Access Compliance Report

Public Rights-of-Way

Intersection ID: 12692	Main Street: WILKINSON_BV	Cross Street: SUTTLE_AV	Location: NE
ADA ID: D5382D95CCD8	Ramp Type: Para	Initial Pass/Fail: Fail	Overall Compliance: No
Severity Score: 1.25			
Codes/Mitigation Info/Possible Solution		Field Measurements/Component Compliance

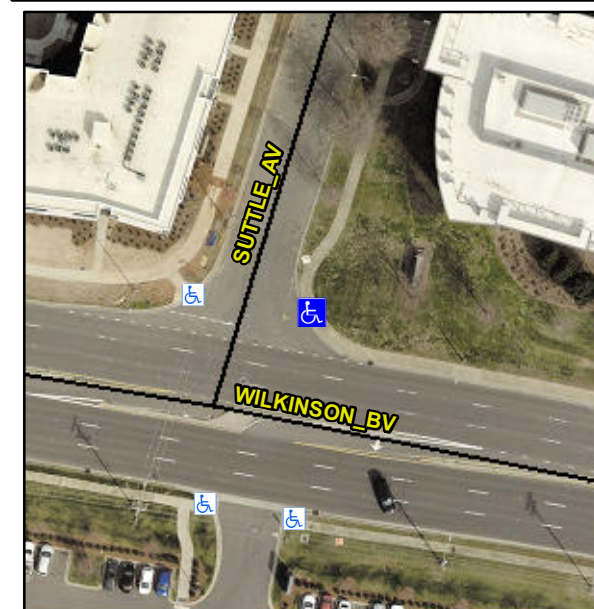
RT RP < 5%

R304.5.3

Remove & Replace Entire Ramp.
